Addendum #	1	Date Issued	April 9, 2026
Project Name Job #	WC Park & Rec Shop		20262250
Bid Date Time	April 16 th , 2026		11:00am Local Time

THIS ADDENDUM AMENDS AND BECOMES PART OF THE CONTRACT DOCUMENTS FOR EAPC PROJECT 20262250 DATED MARCH 25th, 2026, RESPECTIVELY. EACH BIDDER SHALL ACKNOWLEDGE RECEIPT OF THIS ADDENDUM BY MARKING THE ADDENDUM NUMBER AND DATE ON THE BID FORM.

PLAN HOLDERS LIST
 Watford City Park District - Park Shop
 Watford City, North Dakota
 EAPC Project: 20262250

DRAWING TITLE
FIRST FLOOR LIGHTING PLAN

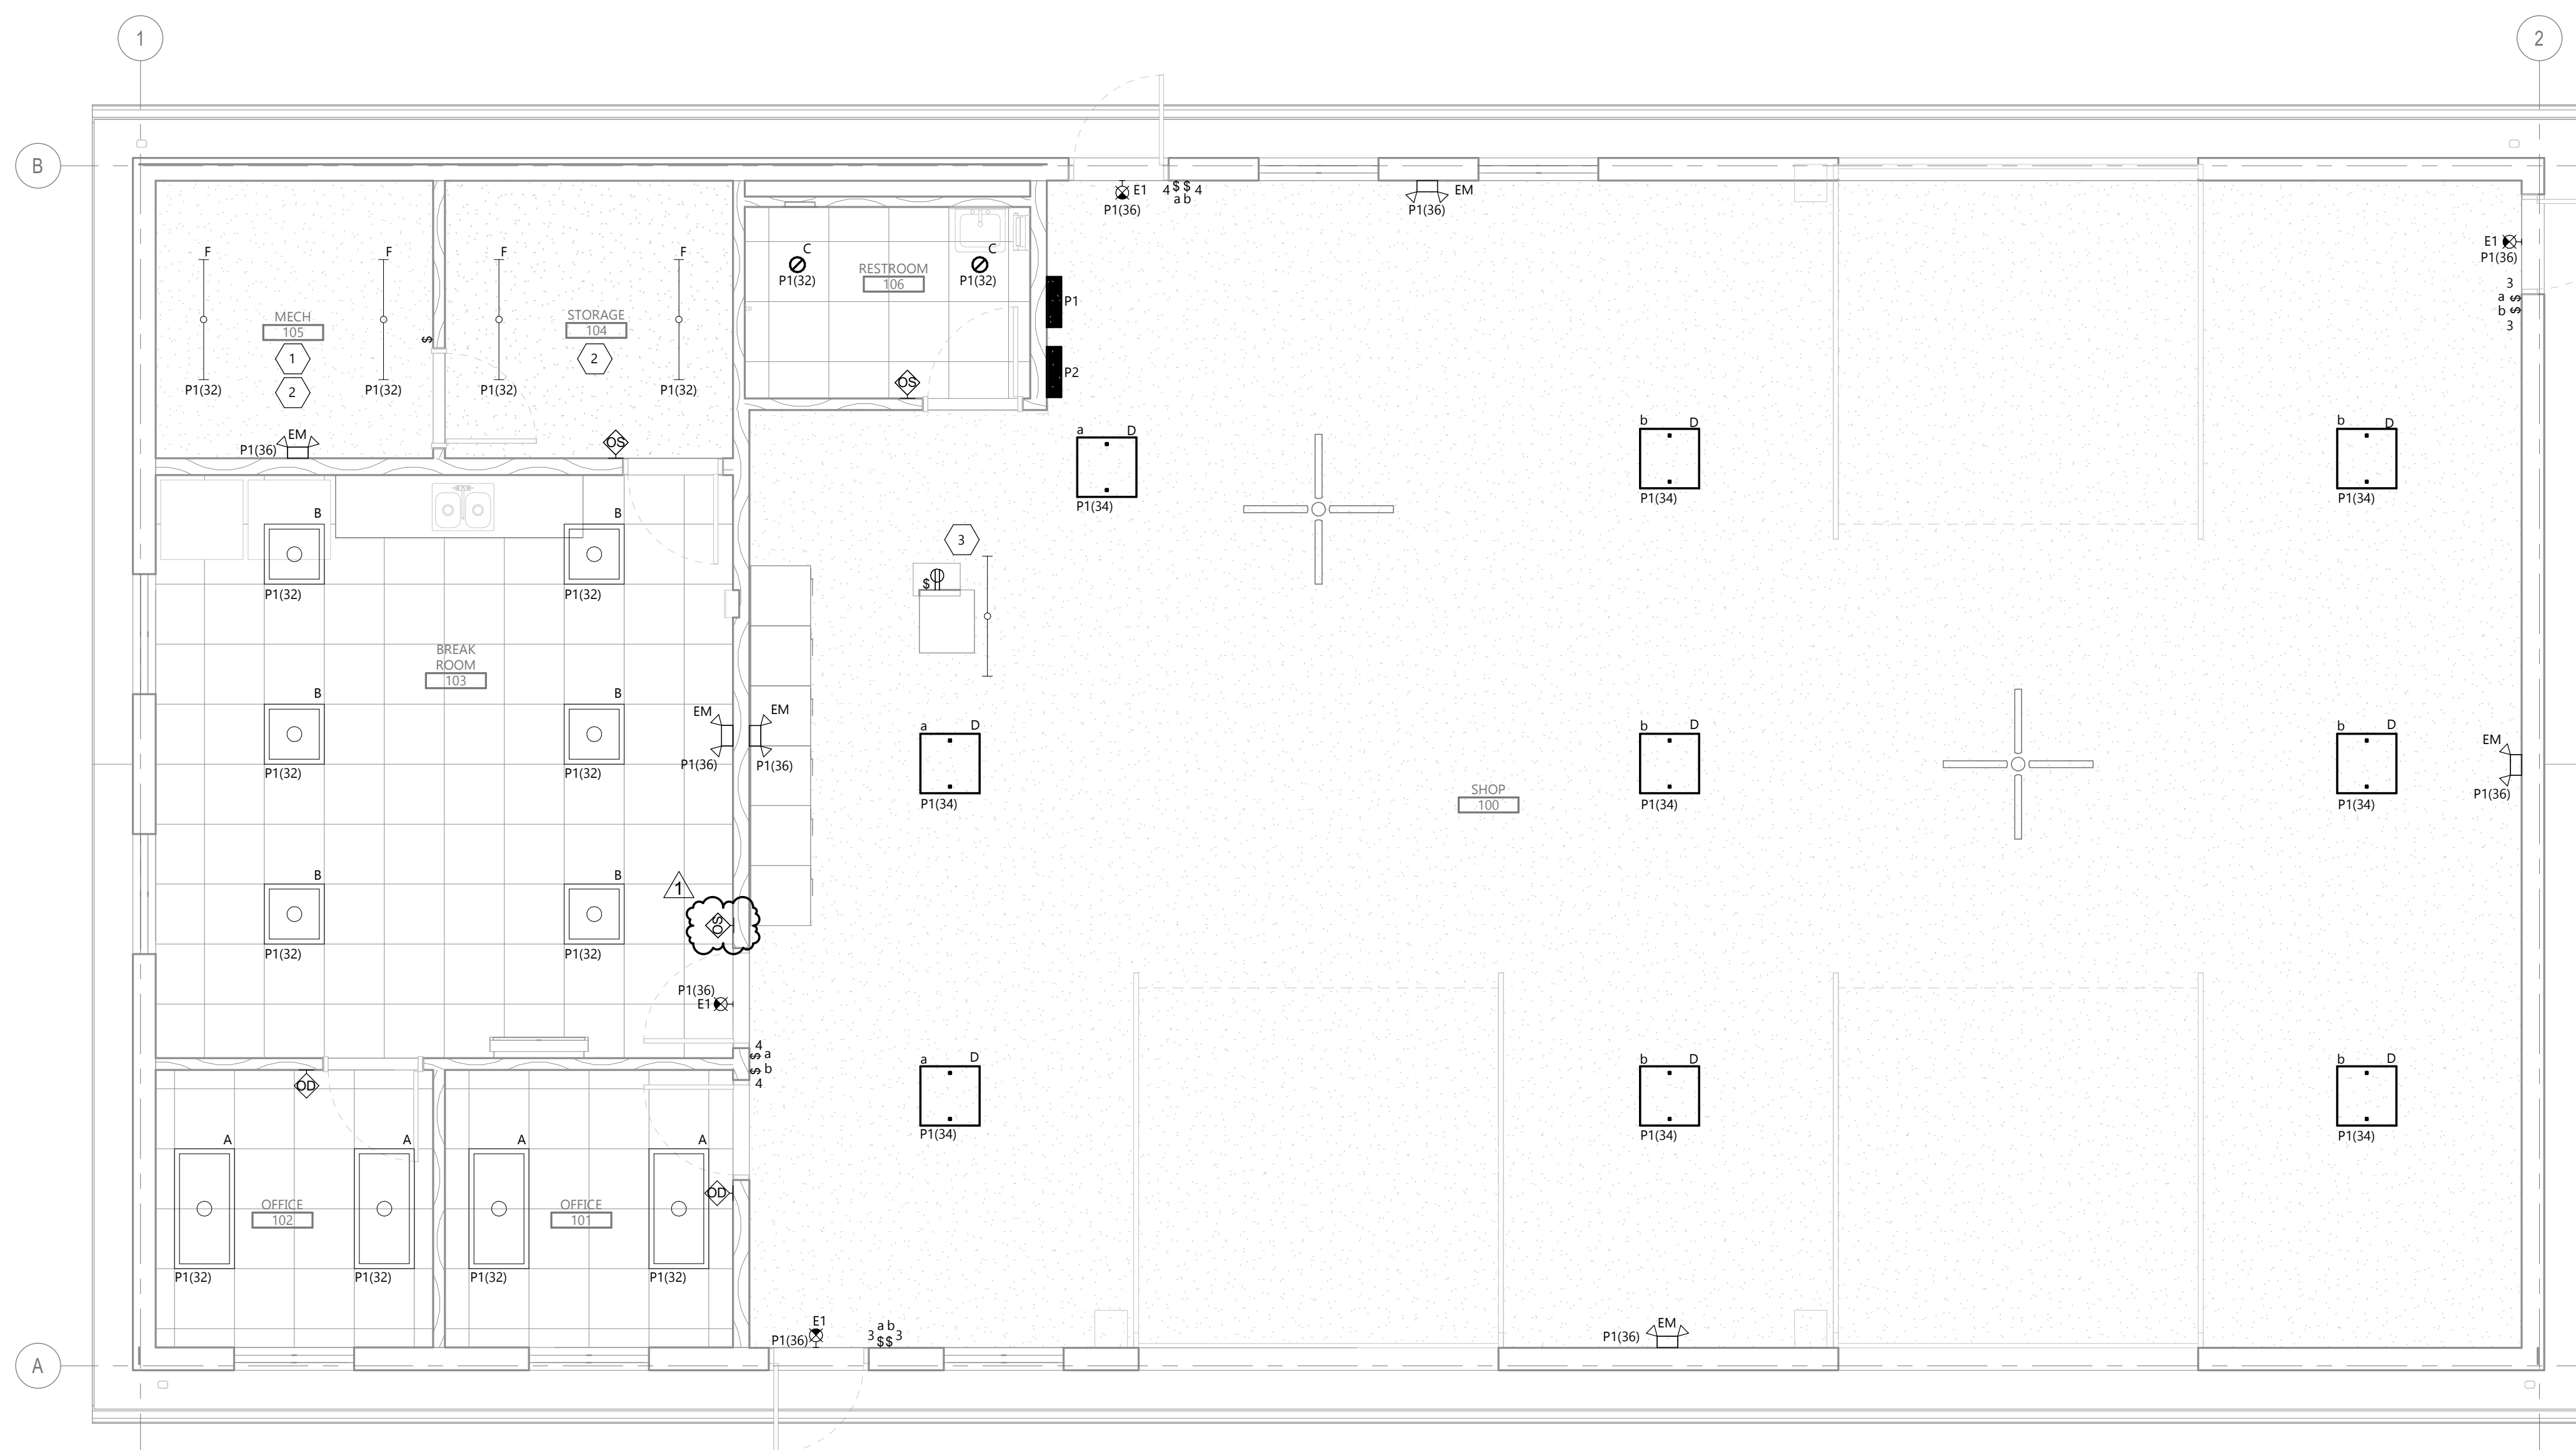
E050	REVISED Spec section 26 0526 to be in numerical order.
E301	REVISED Lighting control in Break Room 103.
E801	ADDED Energy monitoring system to meter.
	ADDED Separate meter for owner and utility.

1 FEEDER RISER DIAGRAM
E801 NOT TO SCALE

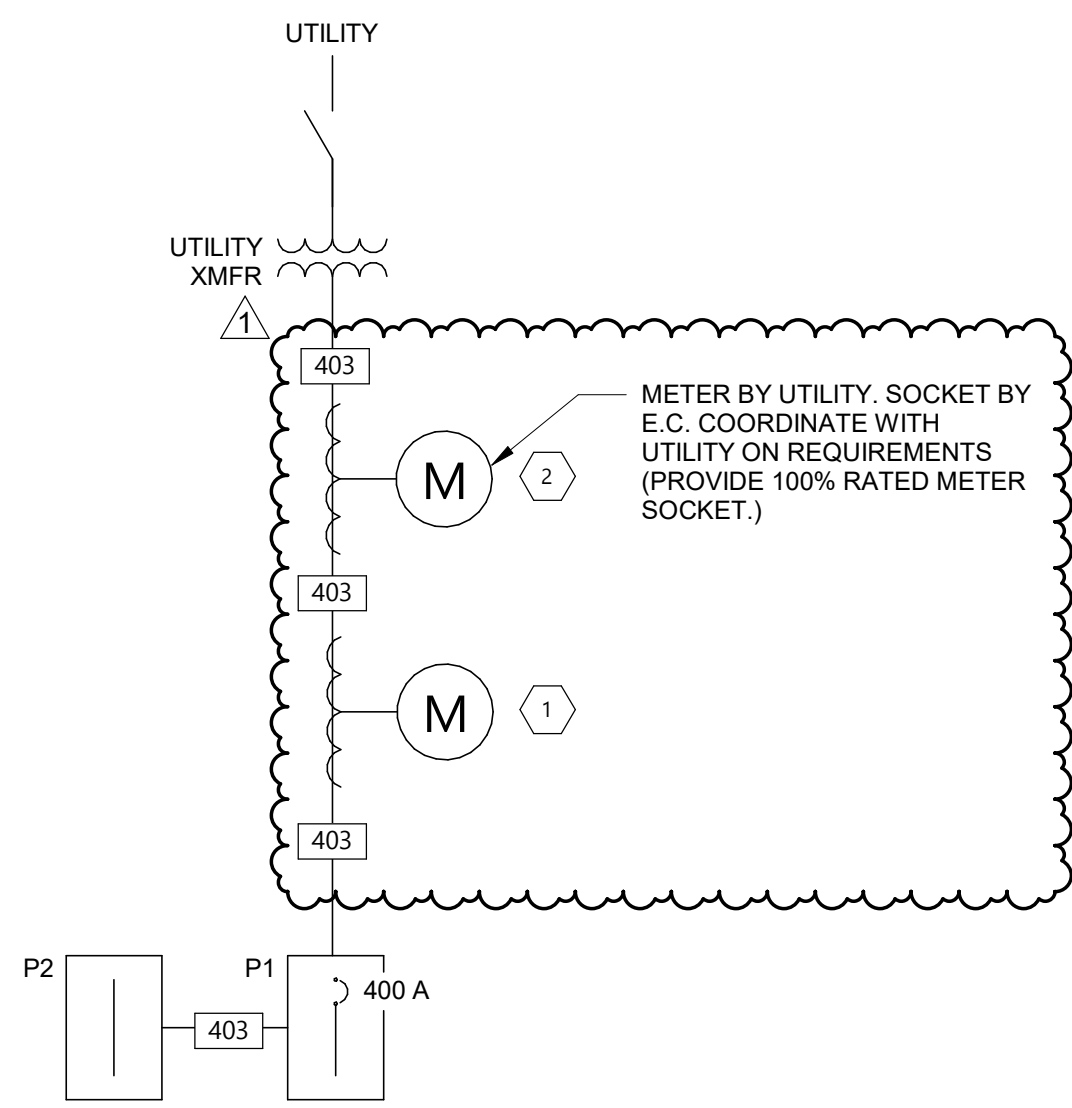
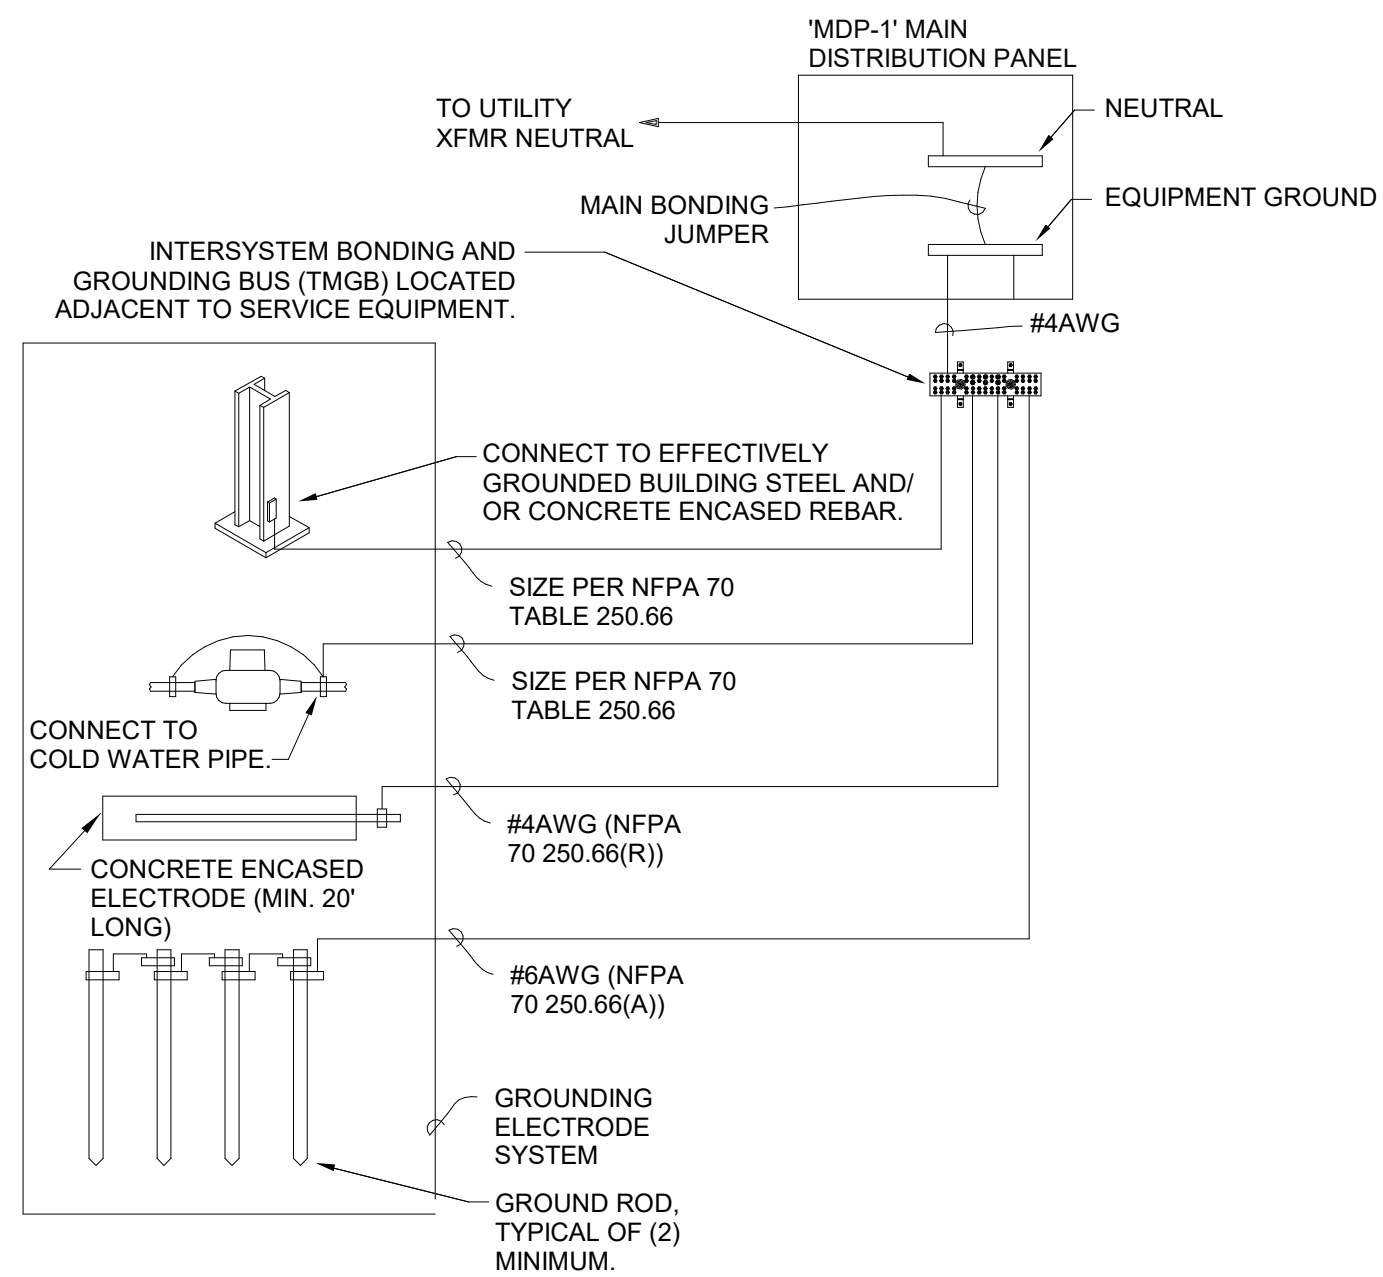
ADDED Sheet notes for bypass lever and energy monitoring system.

- SHEET NOTES**
- ENERGY METER SHALL BE VERIS INDUSTRIES E5X OR APPROVED EQUAL. METER SHALL HAVE BACNET AND ETHERNET CARDS. METER SHALL BE SET UP BY EC FOR RECORDING PEAK DEMAND AND INSTANTANEOUS VALUES.
 - METER SOCKET SHALL BE EQUIPPED WITH LEVER BYPASS AND SHALL BE SELECTED FROM MDU APPROVED METER SOCKETS.

1 SINGLE DOOR CARD READER ROUGH-IN DETAIL
NOT TO SCALE

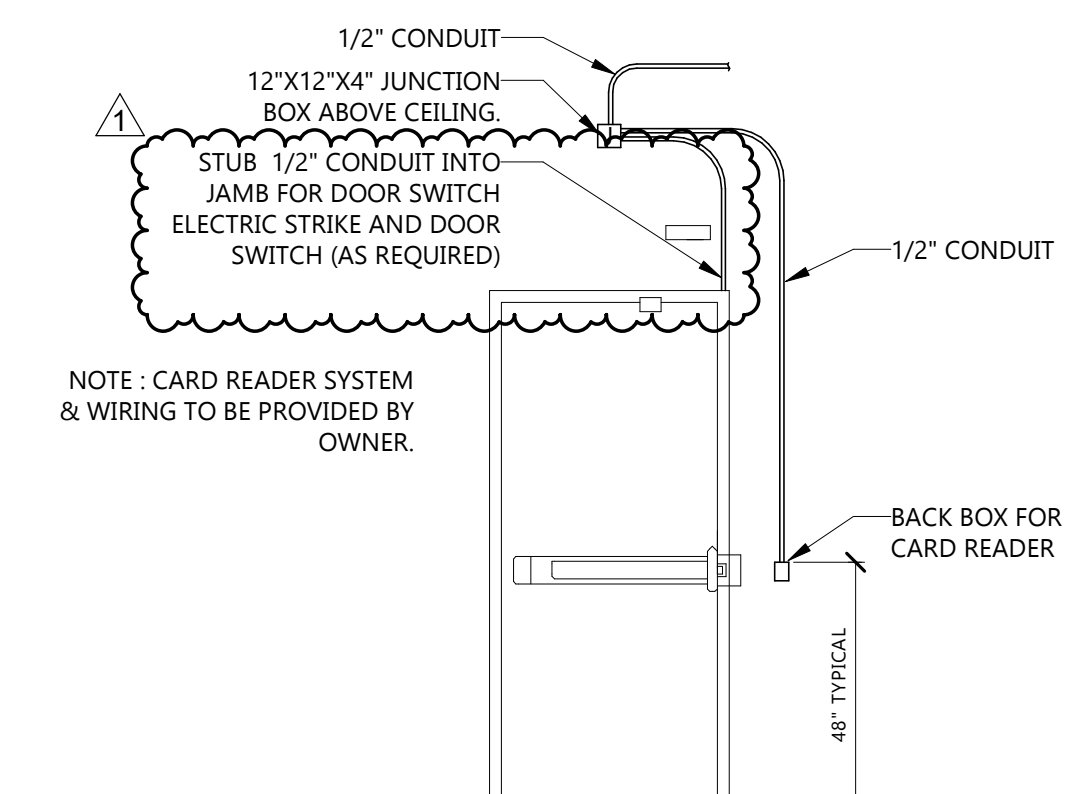
E804 **REVISED** Single Door Card Reader Rough-in Detail for clarity.
